DEVELOPMENT REVIEW COMMITTEE (DRC) COMMENT REPORT

PROJECT NAME: Dorsey Riverbend Neighborhood Stormwater
Improvement

CASE NUMBER: UDP-S22084

REQUEST: Site Plan Level IV Review: Public Purpose Use for
Stormwater Pump Station, Electrical Building, and
Emergency Generator

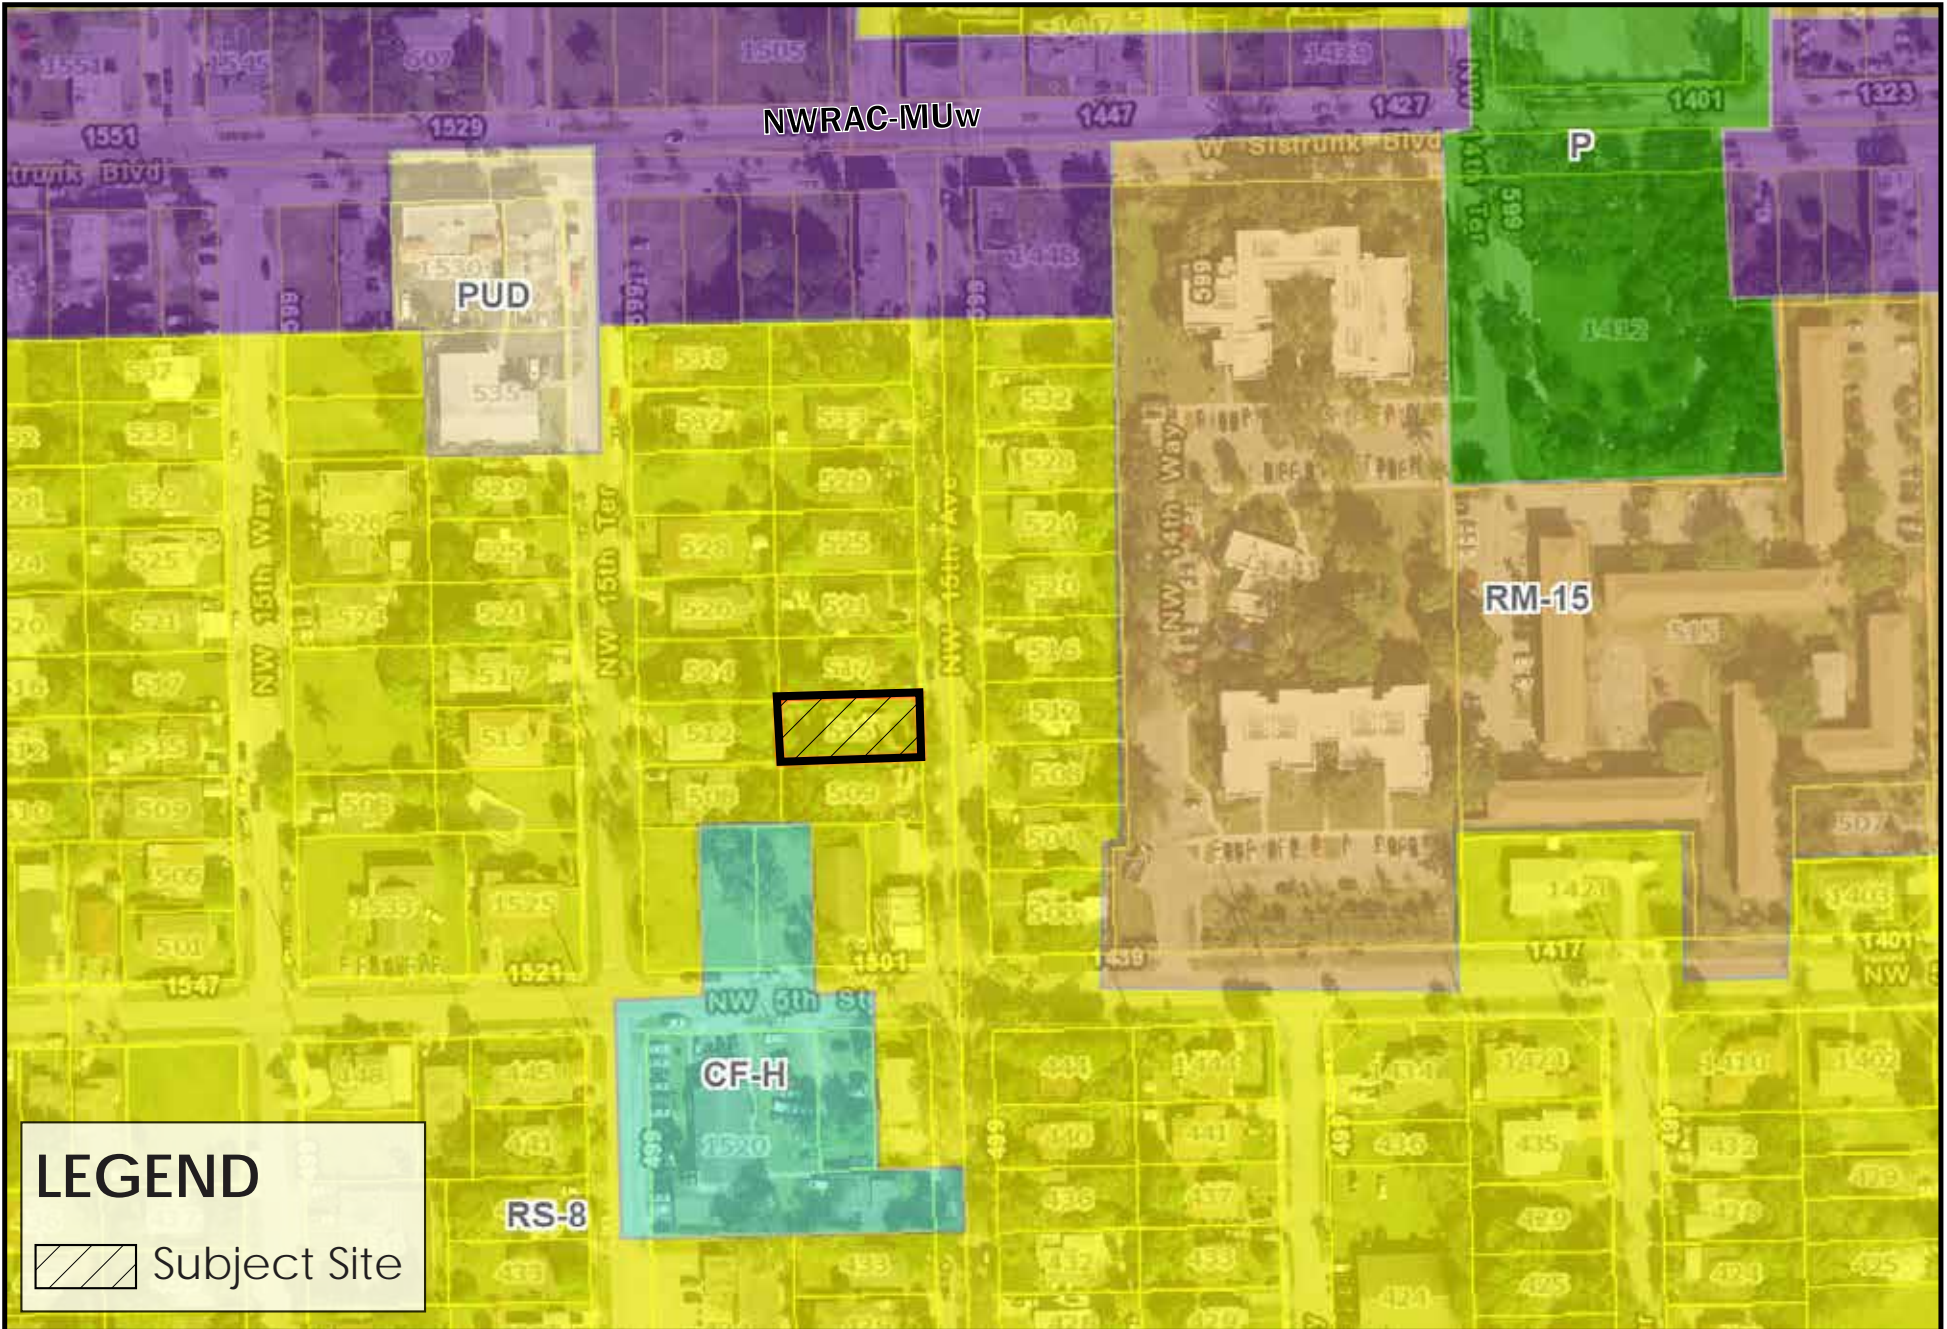
- a. Section 47-25.2, Adequacy Review
 - b. Section 47-25.3, Neighborhood Compatibility
7. Provide the following changes on the Development Application:
- a. On page 3, provide check marks for each item that has been provided as part of the submittal set.
8. Provide the following changes on the site plan:
- a. Provide setbacks of the generator, transformer, electrical building, and any other structure.
 - b. Provide an illustrative site plan clearly depicting structures, location of landscaping, and methods of buffering as per ULDR Section 47-25.3 Neighborhood Compatibility. See below for example of illustrative site plan.
